# Memo

Re: DSP-19020-01 (Landy Property Phase 2)

Figure 6. On-Street Parking Locations

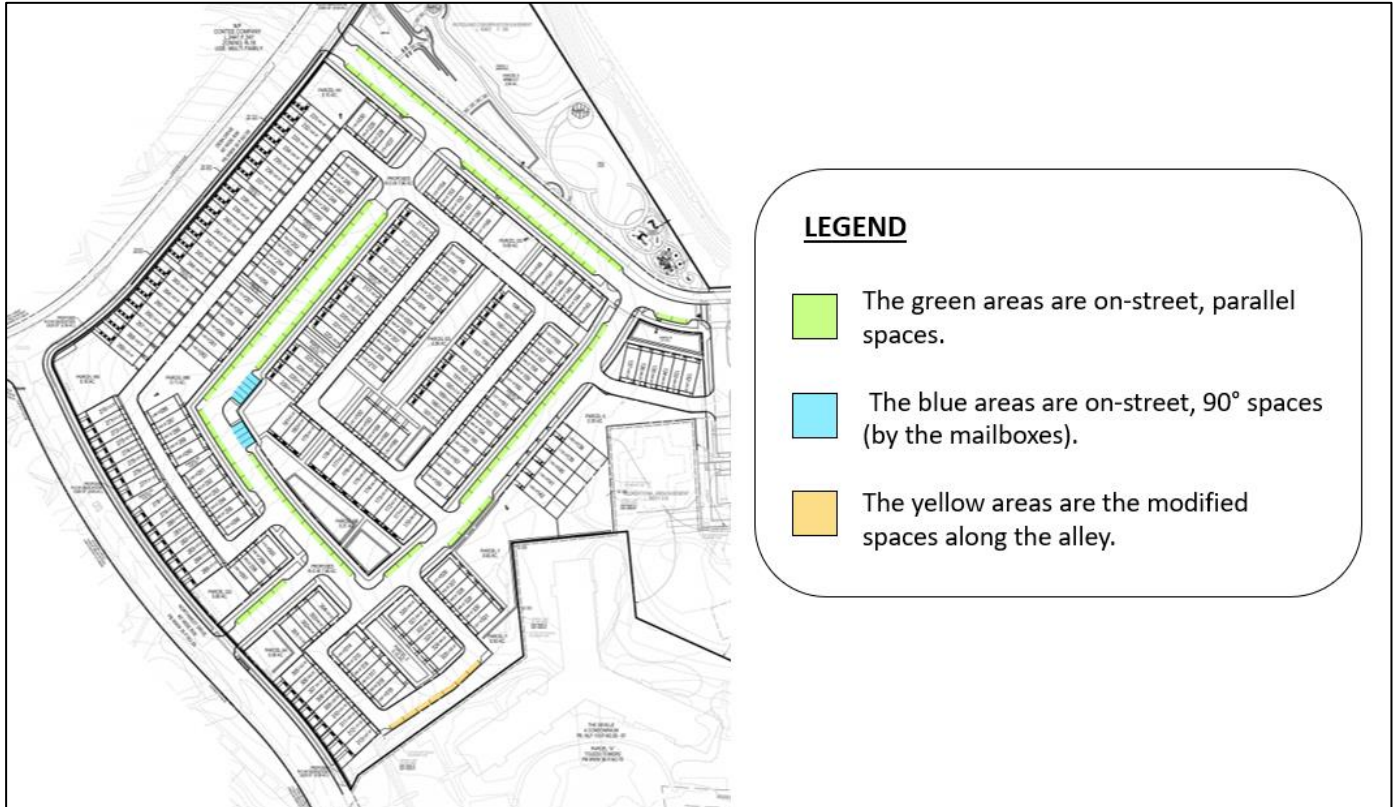
*The Planning Committee supports the two requested modifications:(1) allowing the 11 parking spaces illustrated on the DSP in the alleys and (2) allowing the applicant to exceed the maximum build-to line along the southern end of Dean Drive.*

- Staff recommends all mechanical equipment (above ground transformers, gas meters, etc.) be screened in an aesthetically pleasing manner.
- Staff recommends roadways dedication occur concurrently with dedication of parkland at the time of construction completion.
- Staff recommends 90-degree parking spaces remain private and not be subject to public dedication.
- Staff recommends City Council support the applicant's block standard modification as the 13' extension has been requested to accommodate additional green space.
- Staff recommends City Council support the applicant's setback modification as the requested setback allows for the front facades of attached townhouses to be flush to one another as opposed to being aligned with the curved roadway.
